Austin MG

WHEEL CYLINDER SEALS

TB/70/4/75

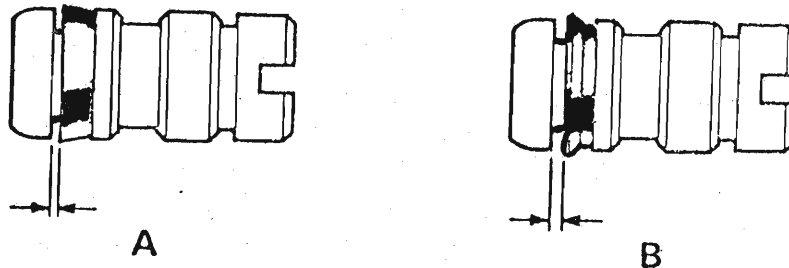
The straight taper wheel cylinder seals, shown at 'A', are being superseded by chamfered lip seals, 'B'. These are shorter than those of the straight taper pattern. (Refer to diagram below).

This difference in length means that the seal occupies less of the groove in the piston.

The increased clearance that results is intentional and must not be taken to indicate an incorrect seal.
